STATE OF CONNECTICUT SITING COUNCIL

**PETITION OF LSE PICTOR LLC
FOR A DECLARATORY RULING
THAT NO CERTIFICATE OF ENVIRONMENTAL
COMPATIBILITY AND PUBLIC NEED IS
REQUIRED FOR THE CONSTRUCTION,
OPERATION, AND MAINTENANCE OF
A 1.99 MW AC SOLAR PHOTOVOLTAIC
FACILITY IN WINCHESTER, CONNECTICUT**

PETITION NO. 1398A

**PETITIONER LSE PICTOR LLC'S RESPONSES TO SITING COUNCIL INTERROGATORIES
DATED MARCH 23, 2021 AND SUPPLEMENTAL SUBMISSION**

SITE DEVELOPMENT PLAN
SHEET 2 OF 16
PROJECT #032-2019
SCALE: 1" = 40'
DATE: 12/22/20, Rev. 3/25/21

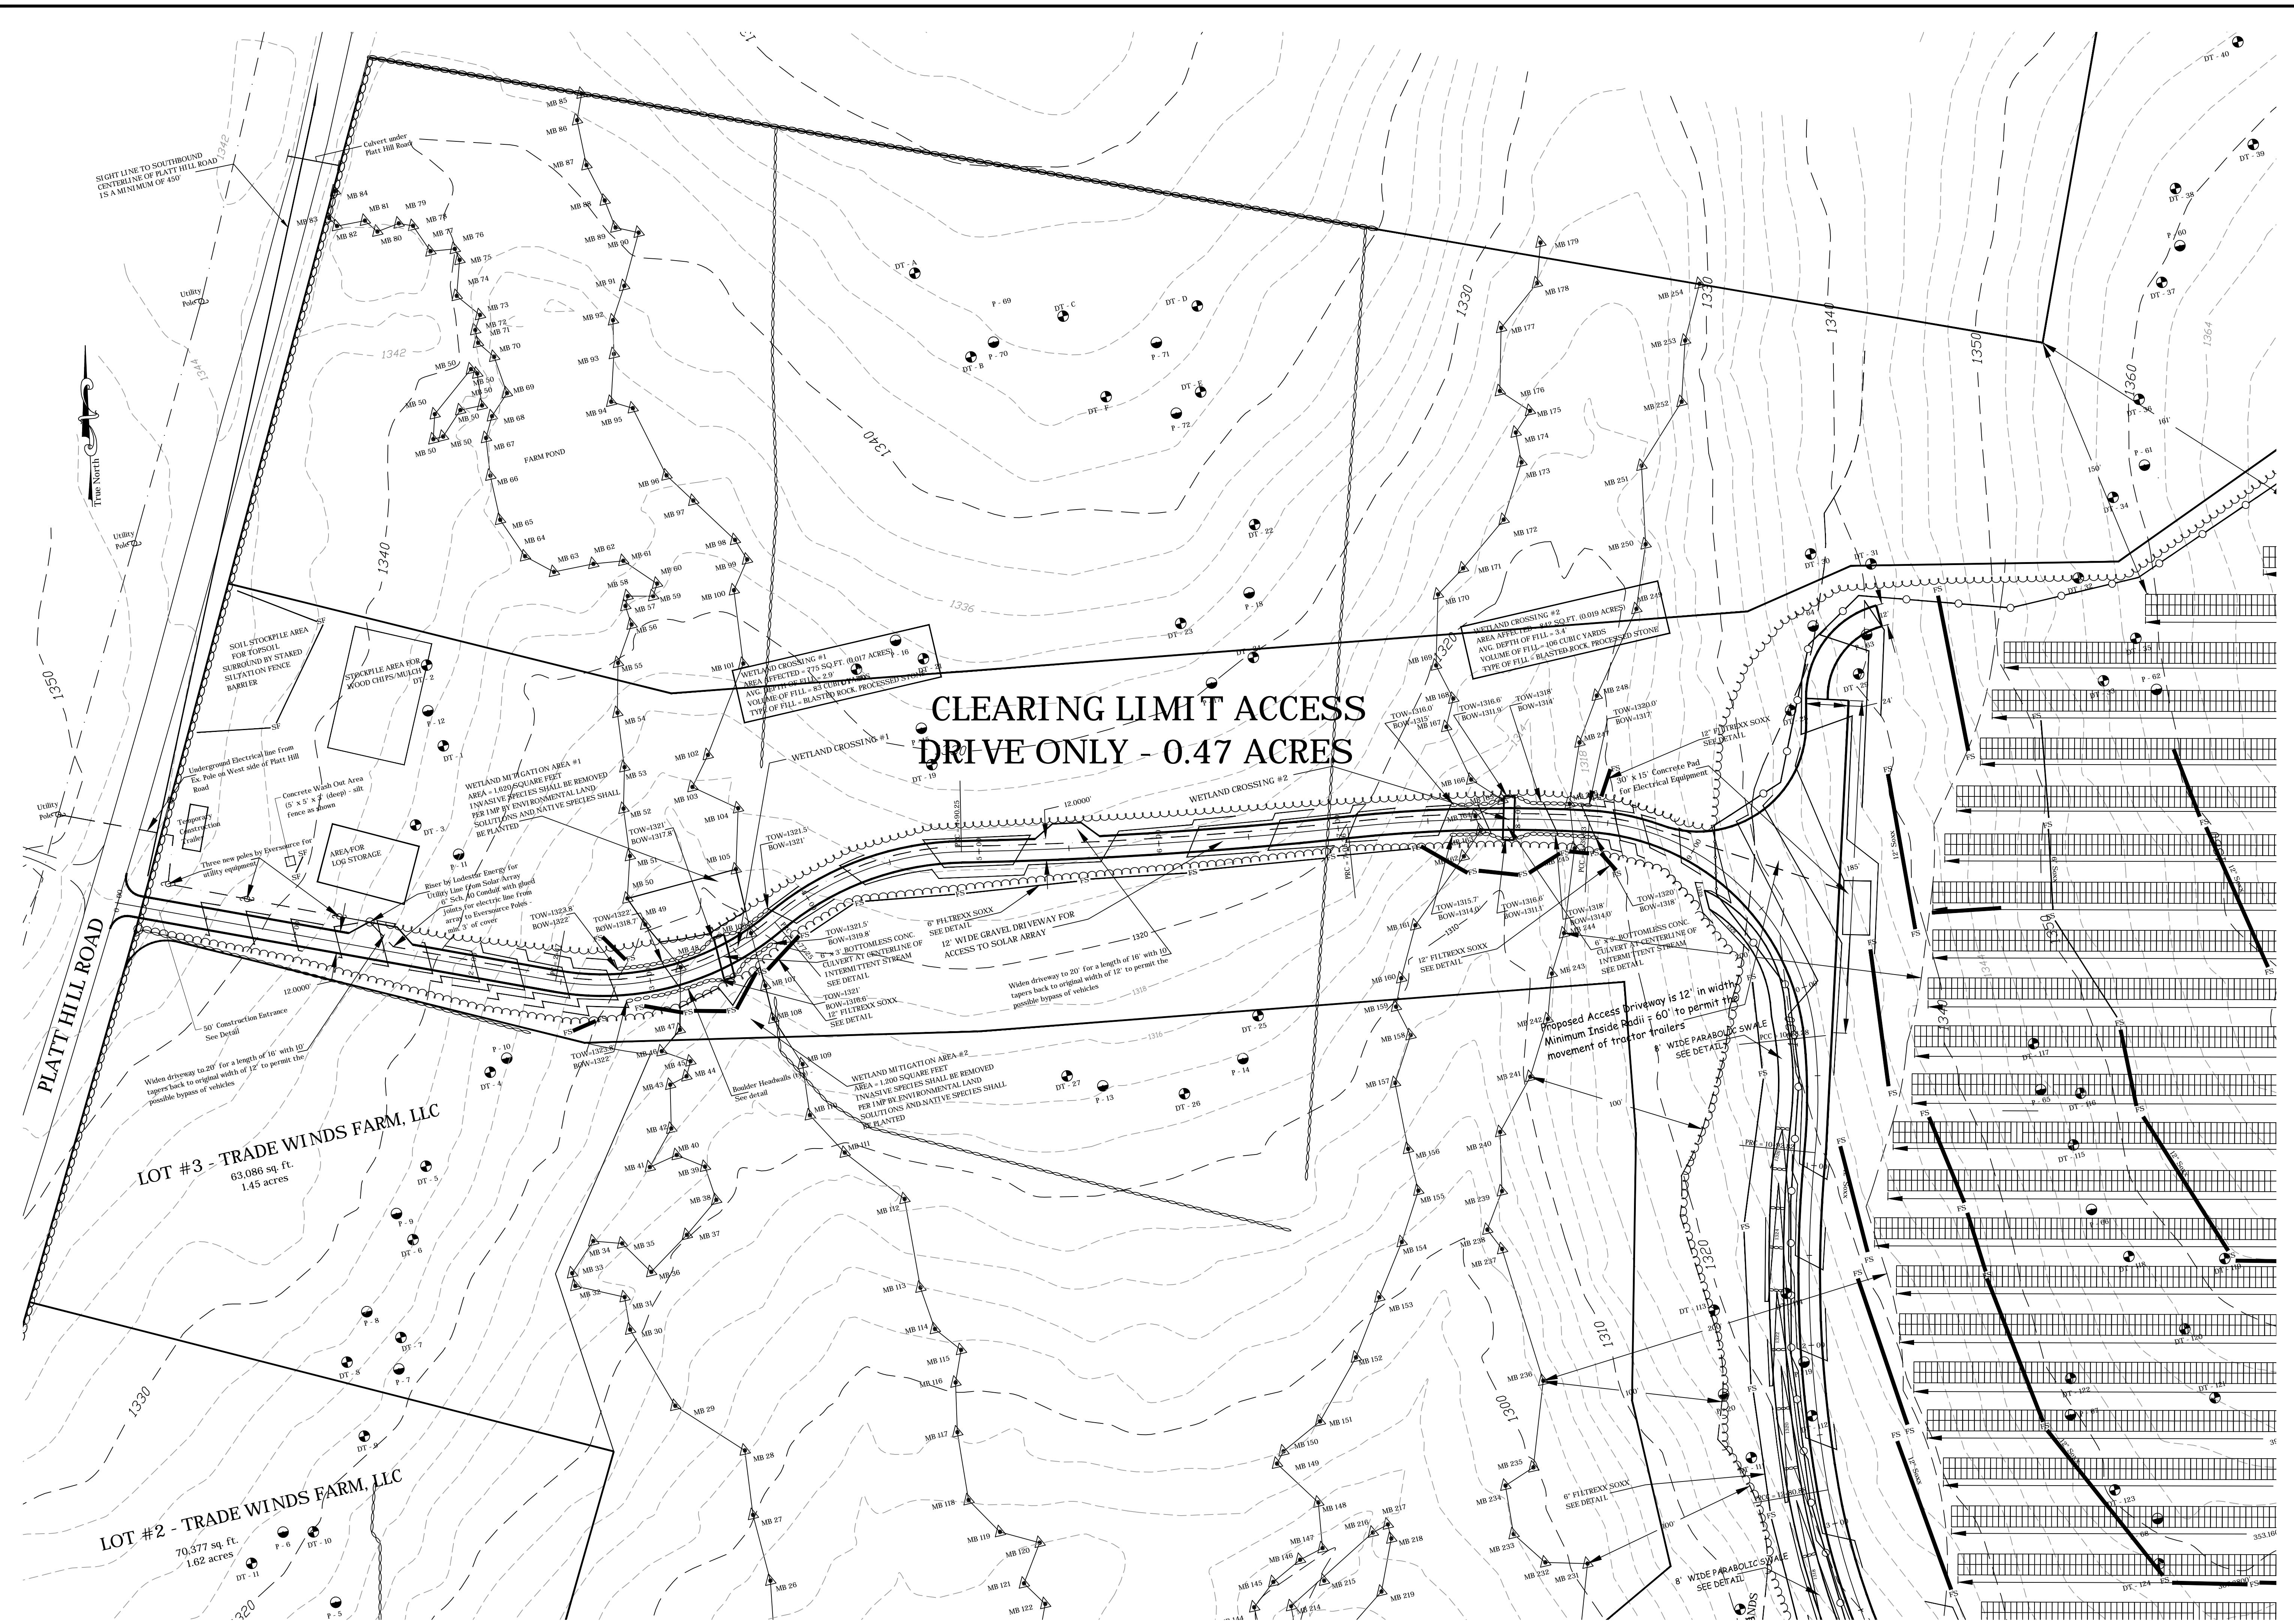
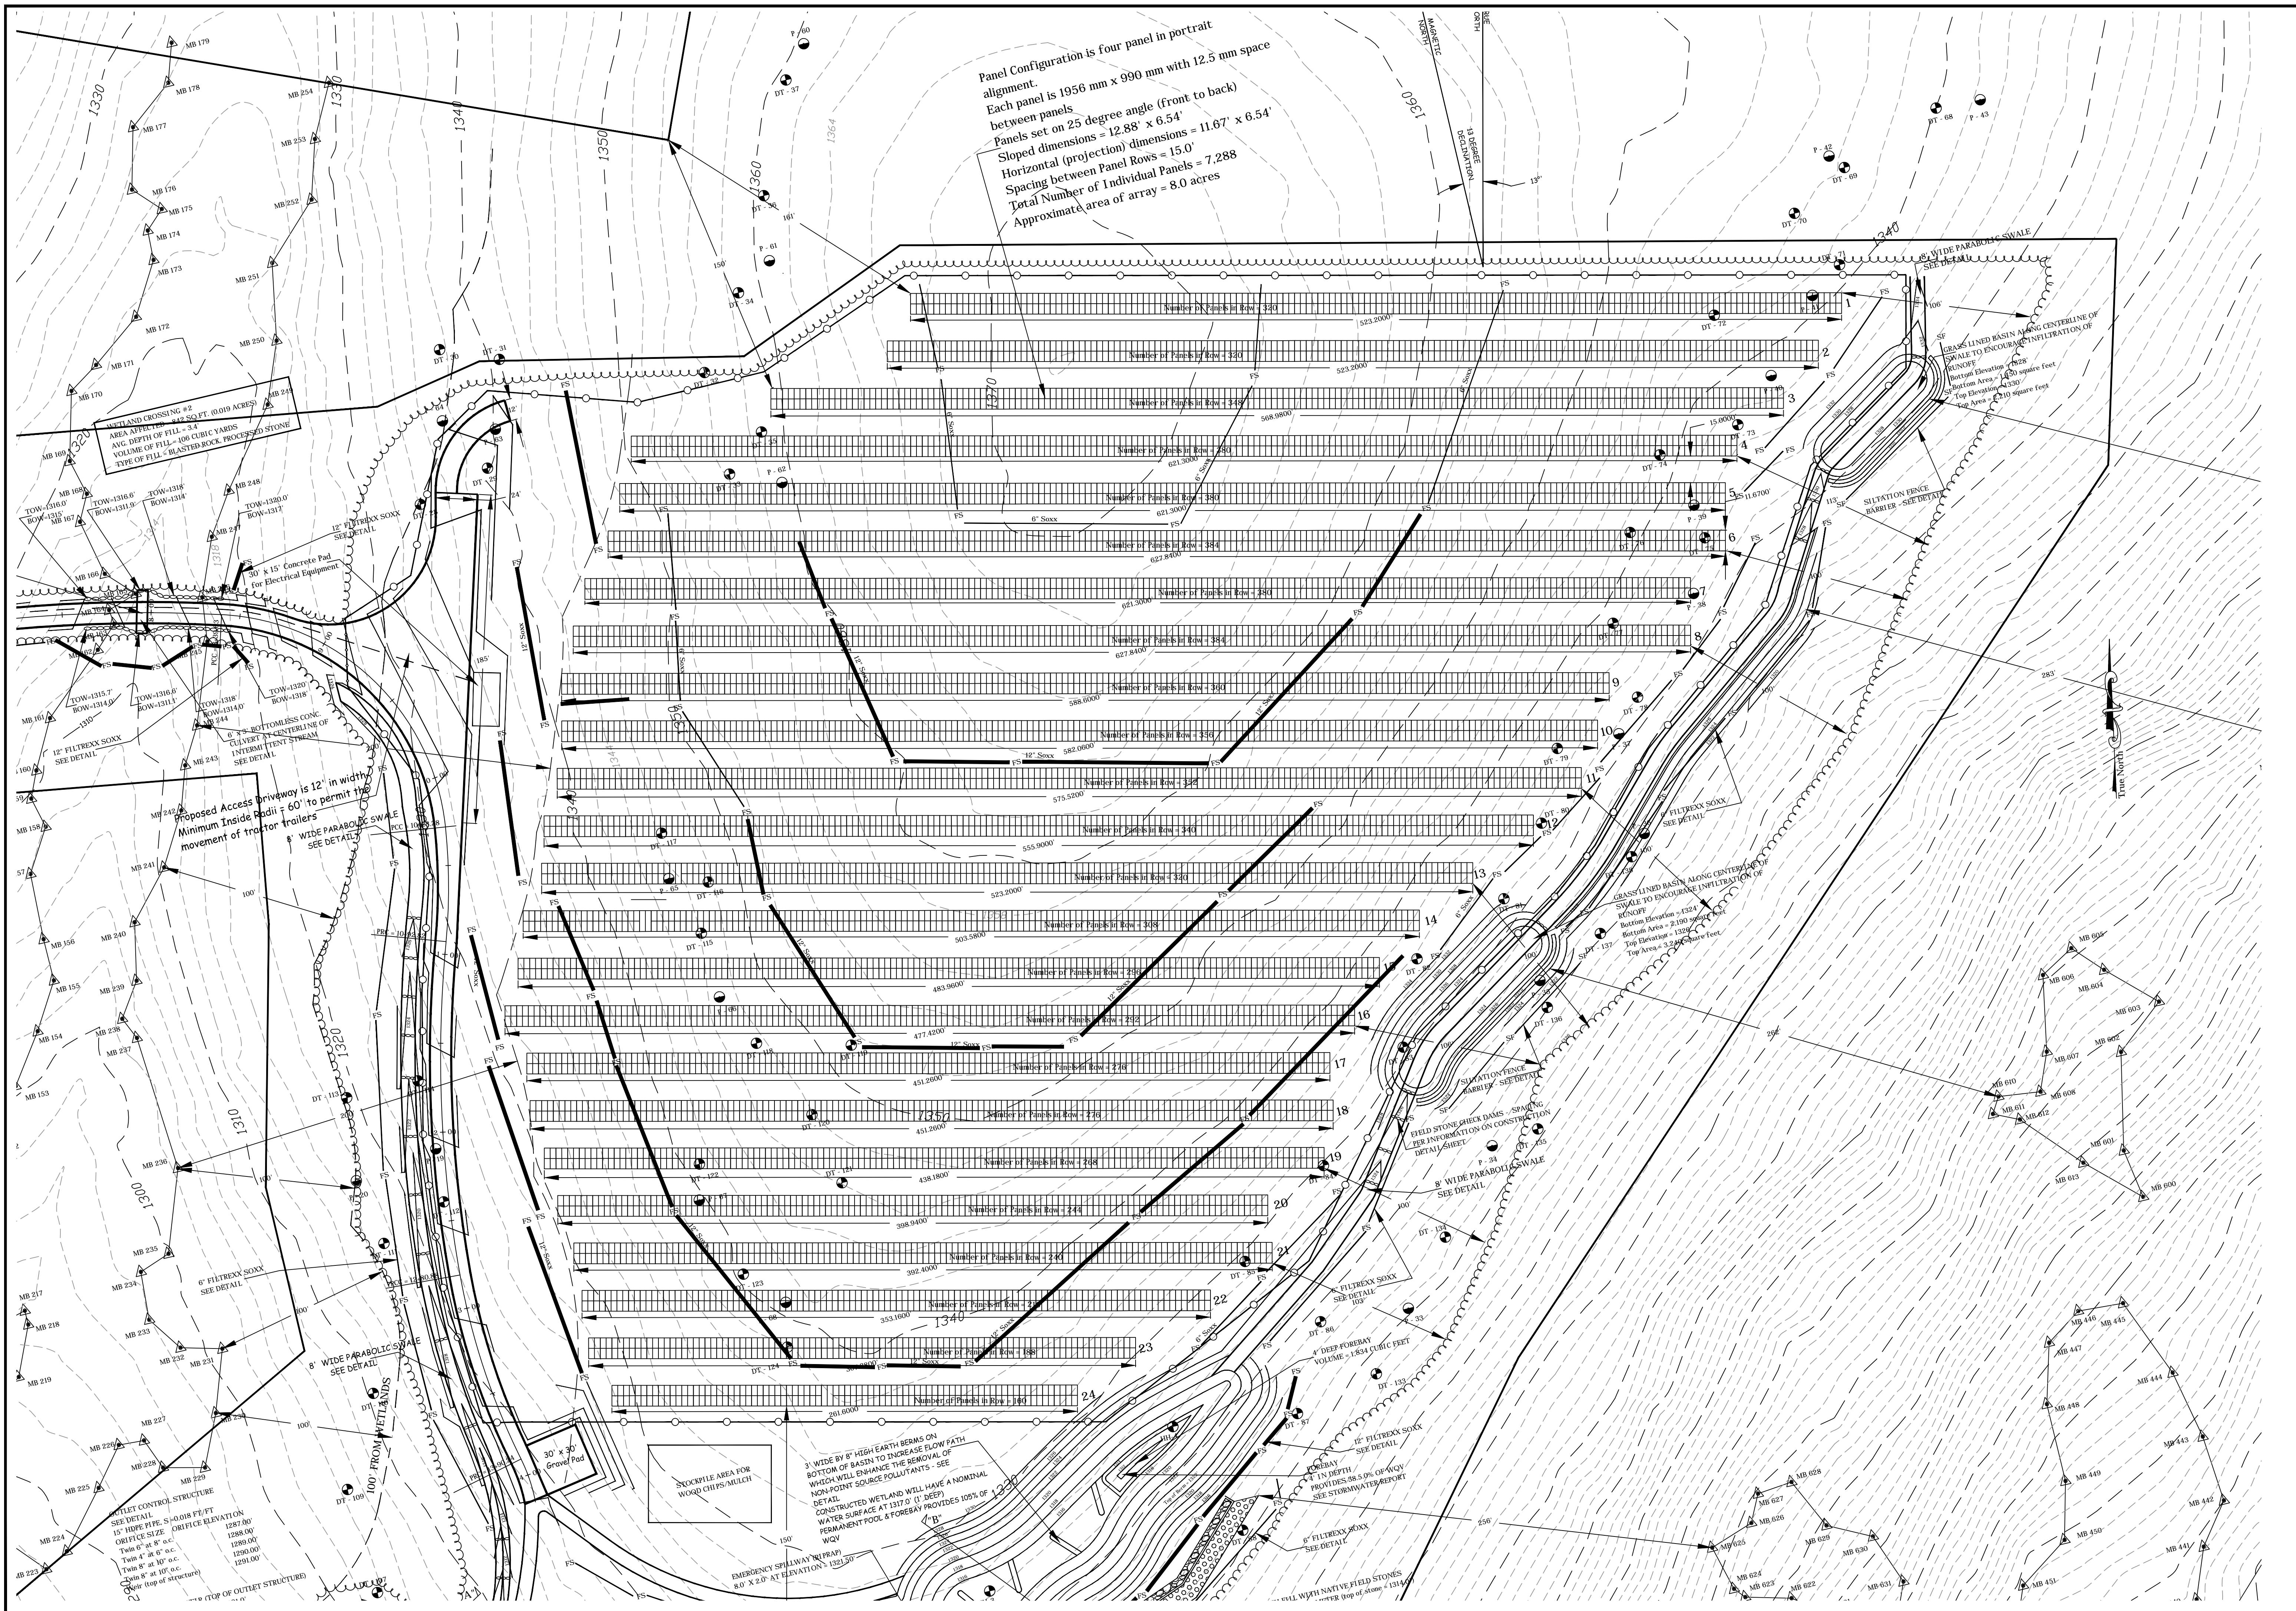
- a. What types of wildlife are expected to use the 18-inch diameter HDPE pipes for wildlife passage?***
- b. What type of substrate would be installed within the pipe?***
- c. Would the pipes serve to transfer water during flood events and thus cause erosion on the downstream side?***
- d. What is the maintenance interval of the wildlife passages?***

4. *Has any consideration been given to spanning both access road wetland crossings with a bridge structure to limit wetland disturbance? If not, why not?*

RESPONSE: The Petitioner has updated the proposed Site plans, attached hereto as Exhibit 2, to utilize open-bottom box culverts in lieu of the proposed pipes to allow for the existing substrate to remain and increase wildlife passage. Small mammals and reptiles are anticipated to use these open-bottom areas. Larger wildlife can travel across the access road. The use of large open-bottom box culverts in lieu of closed-bottom circular pipes means that the natural stream course bottom will be maintained as it exists today, requiring no new substrate and maintaining current flows during flood events and alleviating any erosion impacts downstream. Quarterly maintenance will be conducted along with the planned maintenance of the stormwater basins.

RESPONSE: The Petitioner has updated the proposed Site plans, attached hereto as Exhibit 2, to utilize open-bottom box culverts in lieu of the originally-proposed pipes to allow for the existing substrate to remain and increase wildlife passage. Utilizing a bridge structure would result in a substantial increase in overall Site disturbance with the large foundations required to construct such a structure. Given the very limited use of the access drive once the Facility is constructed, Petitioner believes that the open-bottom box culverts proposed appropriately balance any potential impact of the access drive on wetlands disturbance and overall Site disturbance and vehicular requirements at the Site.
